ATTACHMENT D General Visual Examination Checklist

IP2-GEG-3113
Rev. 1
Rev. Date: 03-10-2000

Component or Zone Number: IWE-046-006

MP-AA (RIGHT) and MP-BB (LEFT)

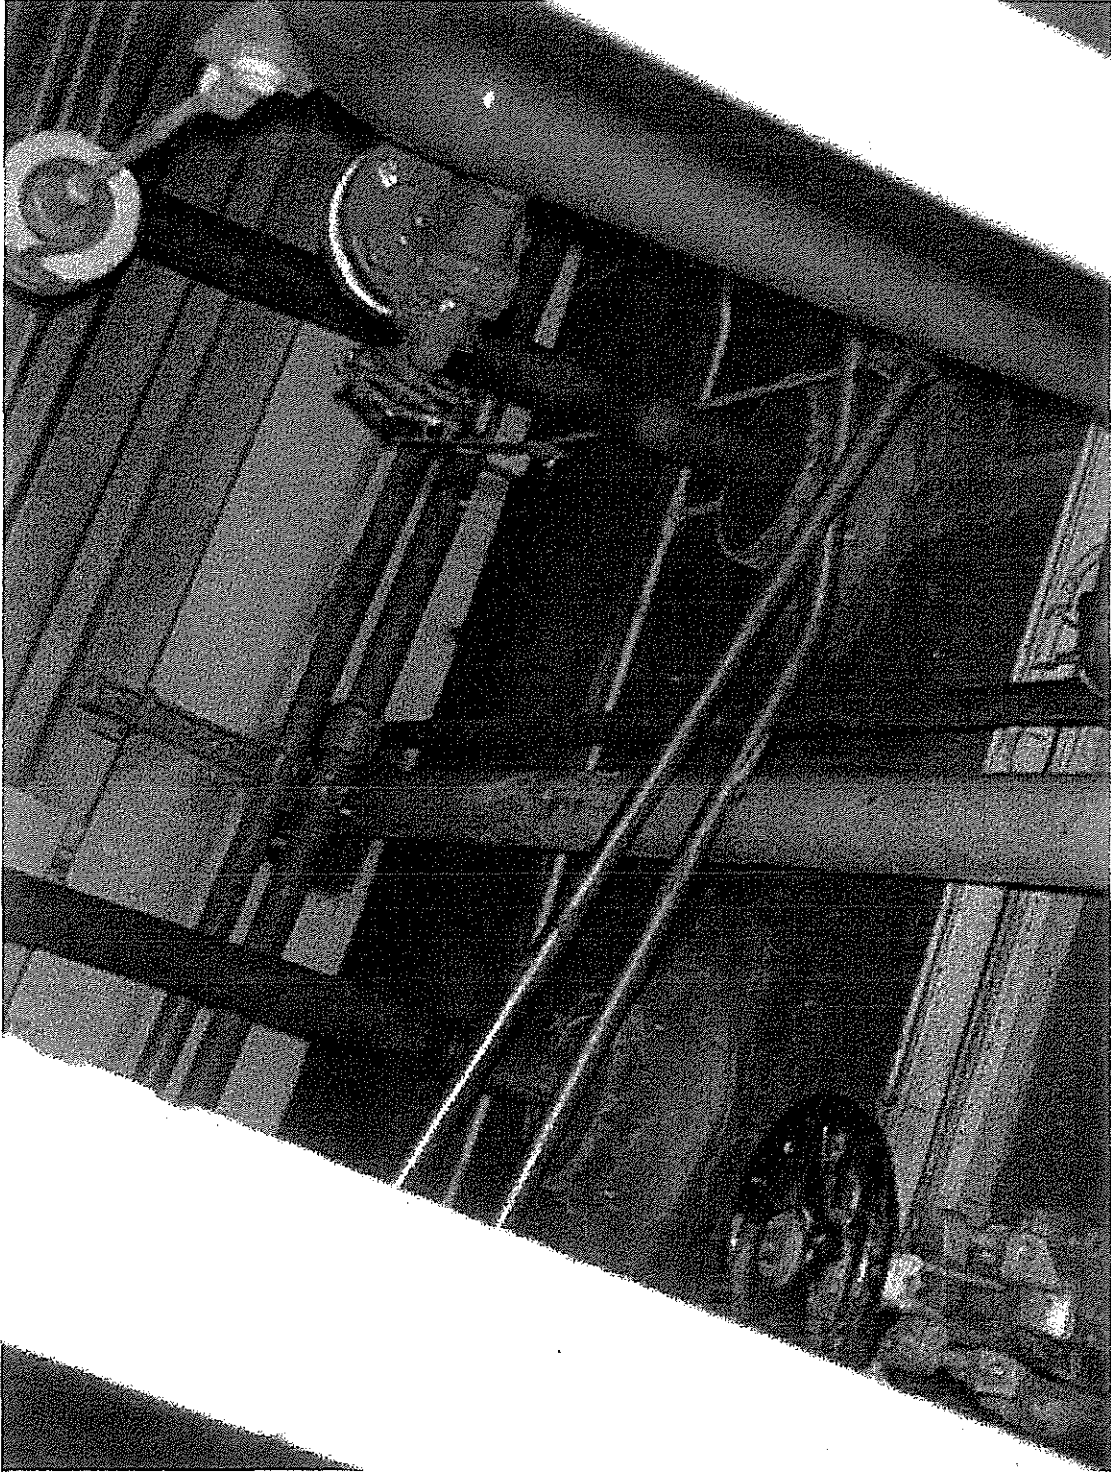
Item No.	Description	Photo
01	Mechanical penetration nos. MP-AA, MP-BB, MP-CC and MP-DD, MP-Q showed surface rusting on the end plates. Penetrations with hot piping will experience service that will not promote an active corrosive environment. Rust staining is classified as ASTM D610, Grade 1 -2. (between 1/3 and 1/2 of the end plate circumference.)	00031619.jpg, 00031620.jpg and 00031628.jpg

Item No.	Discussion	Acceptable	Additional Eval. Req'd.
01	<p>The corrosion on the 3/4" thick penetration head plates has resulted from high temperatures, which have burned off the coating and allowed corrosion of the plate. (MP-AA, BB, CC & DD are for Steam Generator Blowdown lines with process temperatures of 568°F. MP-Q is for a Safety Injection line with process temperature of 250°F.) The corrosion is powdery in form and does not exhibit flaking or pitting which would indicate a more severe condition. During plant operation the piping temperatures will be sufficiently high as to preclude moisture from the head plates and thus the plates will only be subject to corrosion during plant outages. These times are sufficiently short and the corrosion rates sufficiently low as to not result in significant loss of material (i.e., well less than 10% as discussed in IWE-3512.3). Corrosion on the penetration sleeves is general surface corrosion that has not resulted in any significant loss of material. Examination at the next regular inspection period is sufficient to monitor these conditions.</p>	✓

LINER INSPECTION ZONE IWE-068-001
 (INTERIOR DEVELOPED VIEW, LOOKING INSIDE OUT)

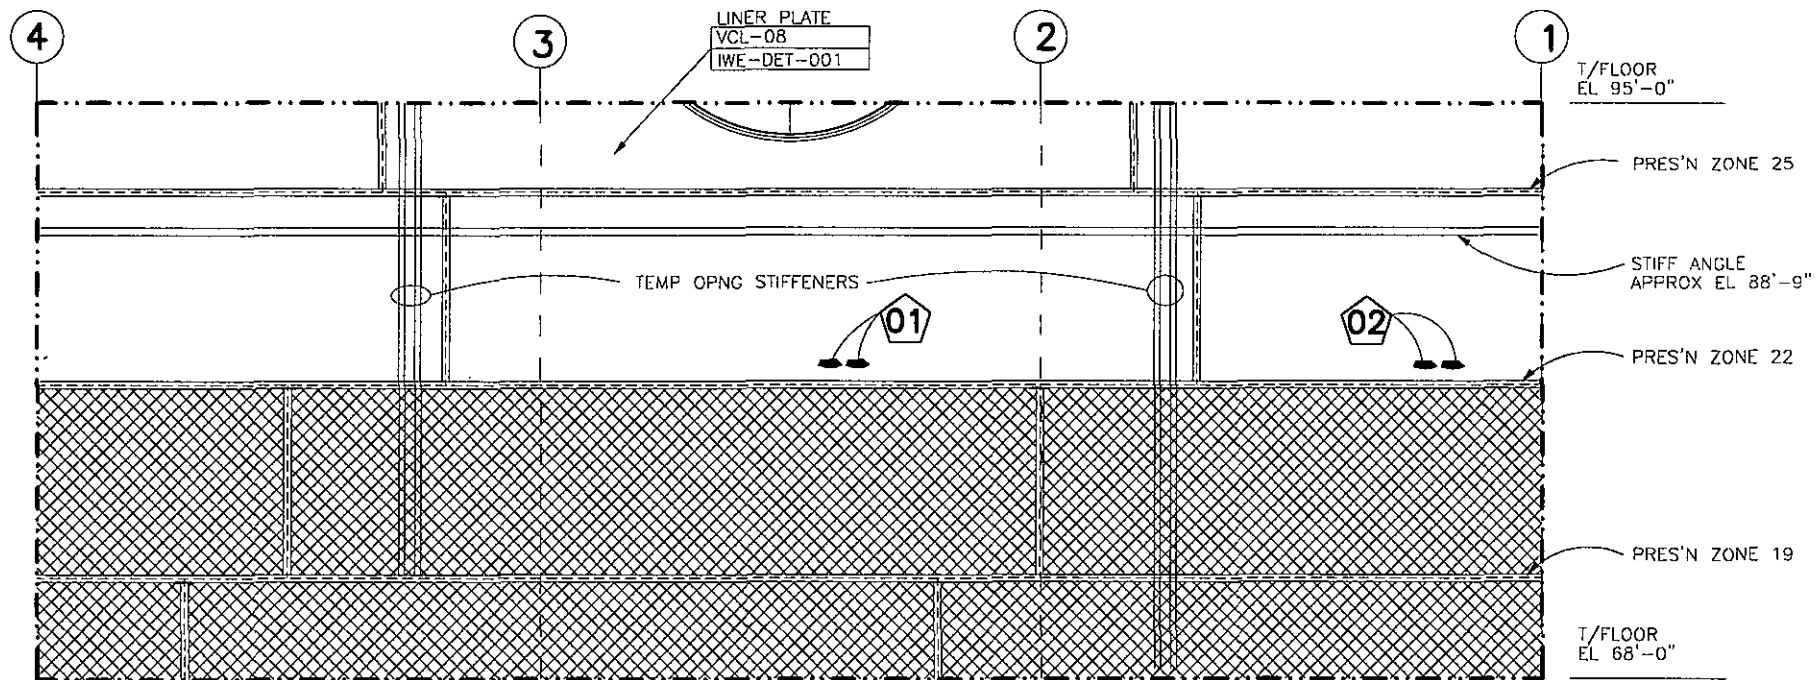
Item No.	Description	Photo
01	Two areas approximately 1"x1" located 12" above insulation halfway between Col. 2-3 show mechanical nicks in topcoat. Primer intact.	None
02	Two areas approximately 1"x1" located 8" above insulation between Col. 1-2 show mechanical nicks in topcoat. Primer intact.	None

Item No.	Discussion	Acceptable	Additional Eval. Req'd.
01, 02	The nicks in the coating are mechanical damage that has removed the top coat. Since the primer is intact, the liner will be protected and there is no significance to this condition.	✓

LINER INSPECTION ZONE IWE-068-002
 (INTERIOR DEVELOPED VIEW, LOOKING INSIDE OUT)

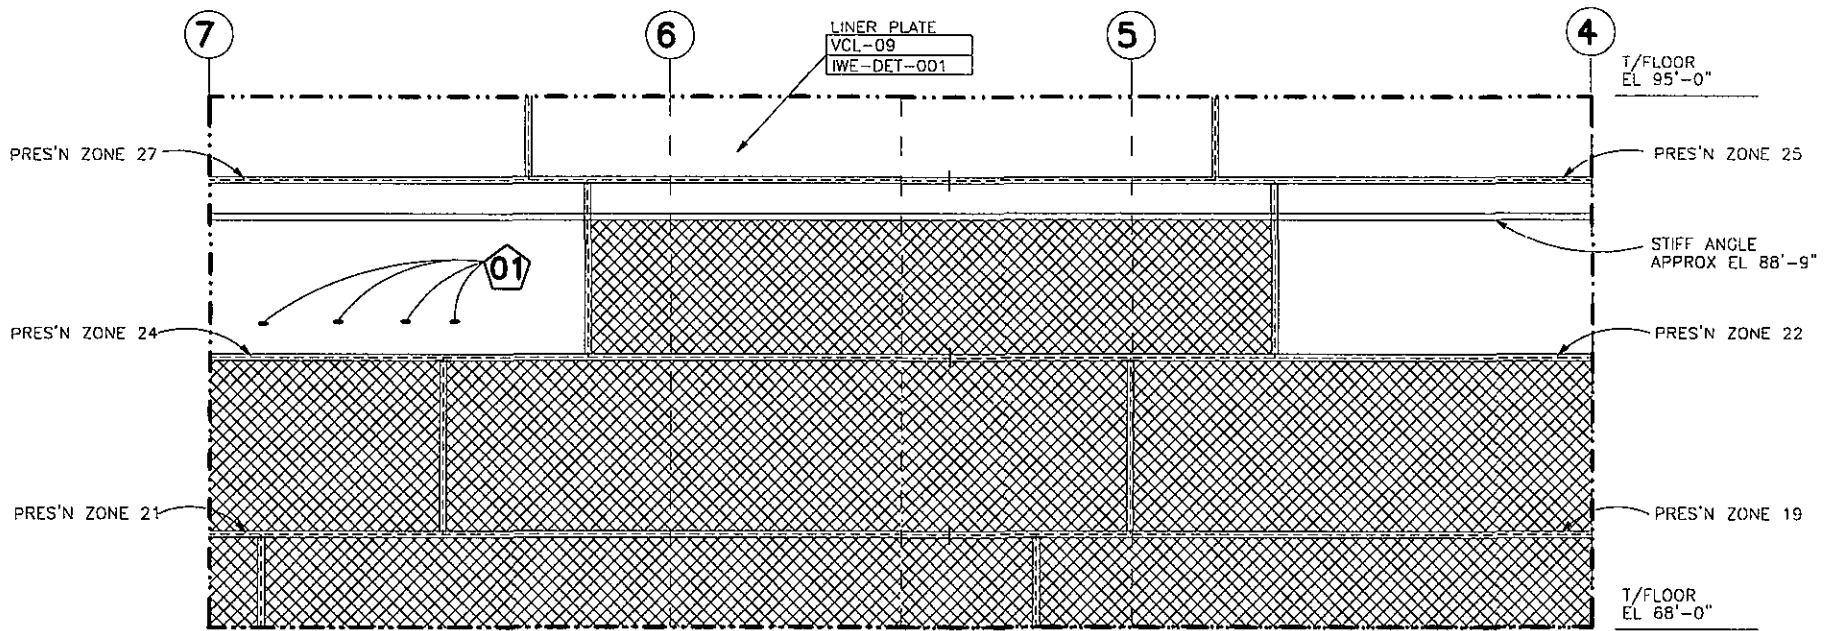
Item No.	Description	Photo
01	Four (4) areas approximately 3" in length between Col.6-7 show touch-up coat checking and peeling. Primer intact. Checking classified as ASTM D660, Mosaic Grade 8.	None

Item No.	Discussion	Acceptable	Additional Eval. Req'd.
01	The coating deterioration is limited to the top coat. Since the primer is intact, the liner will be protected and there is no significance to this condition.	✓

LINER INSPECTION ZONE IWE-095-001
(INTERIOR DEVELOPED VIEW, LOOKING INSIDE OUT)

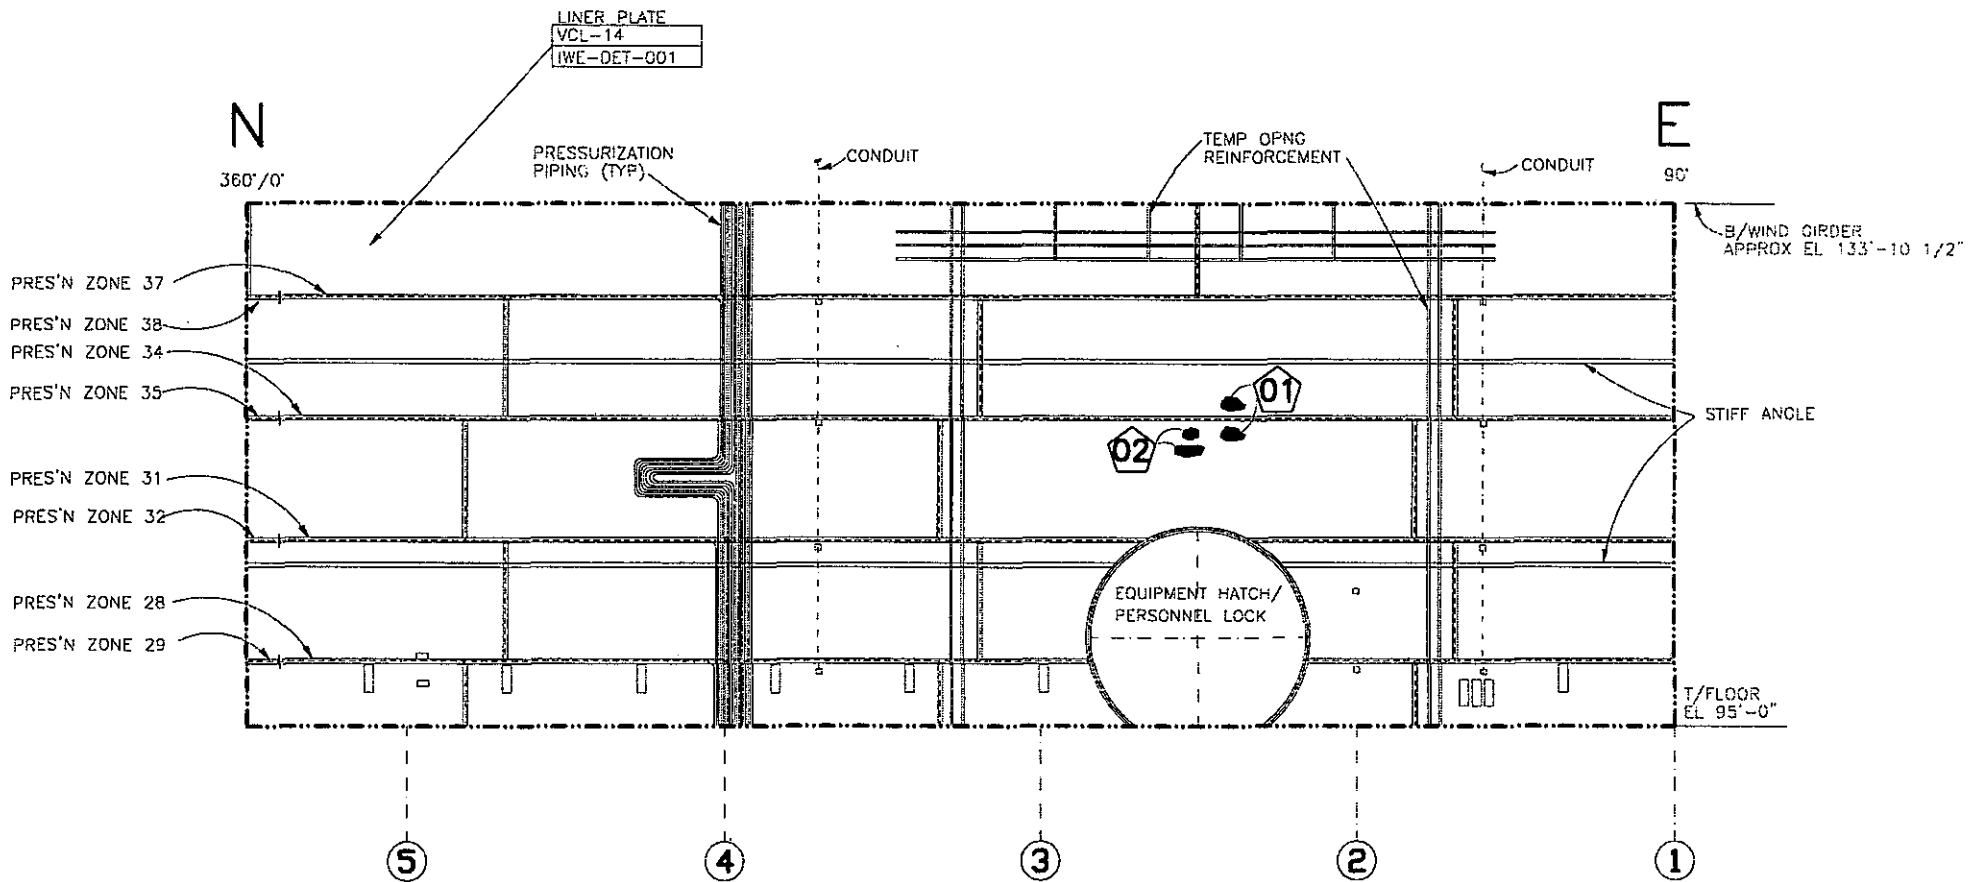
Item No.	Description	Photo
01	Coated 3" round liner attachment above equipment hatch shows minor rusting. Rusting is classified ASTM D610, Grade 5, (3% of surface rusted). Also, area below attachment shows top coat delamination, checking and peeling. Primer intact in both areas. Checking to ASTM D660, Mosaic, Grade 8.	None
02	Two coated areas above equipment hatch show grinding depressions in liner plate. Coating intact.	None

Item No.	Discussion	Acceptable	Additional Eval. Req'd.
01	Neither the rusting of the attachment nor the coating deterioration has degraded the liner. The primer was observed to be intact and thus the liner is protected. Examination at the next regular inspection period is sufficient to monitor this condition.	✓	
02	The subject depressions do not reflect ongoing degradation of the liner. Based on the fact that they are coated and the coating is intact, they apparently remain from original construction or from some previous plant activity.	✓
